Engineering Design Standard Section 6-5

ADDENDUM TO BUCKEYE SIGNING AND MARKING DESIGN STANDARDS

Request No. <u>4</u>	APPROVED: Y / N	ADDENDUM NUMBER <u>SM3</u>
----------------------	-----------------	----------------------------

Revised Standard Number: Detail 65120

Detail - 65120

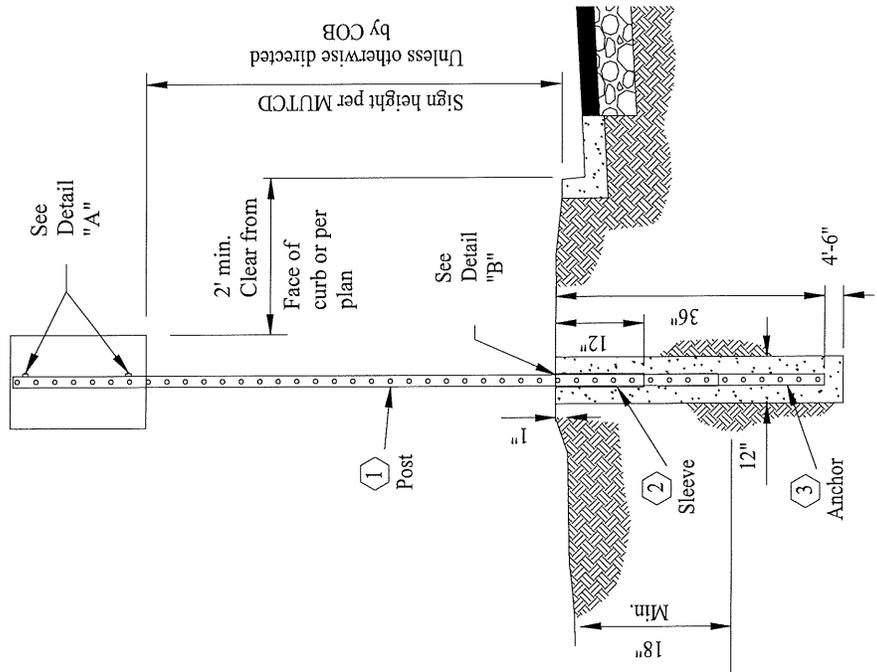
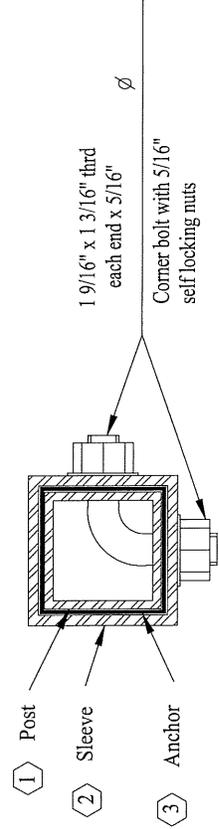
Detail 65120 - Revise anchor, sleeve and Post size.

- ① Post- 2" x 2" square perforated 12 gauge galvanized tubing
- ② Sleeve- 2-1/2" x 2-1/2" x 18", square perforated 12 gauge galvanized tubing
- ③ Anchor- 2 1/4 " x 2 1/4" x 36", square perforated 12 gauge galvanized tubing
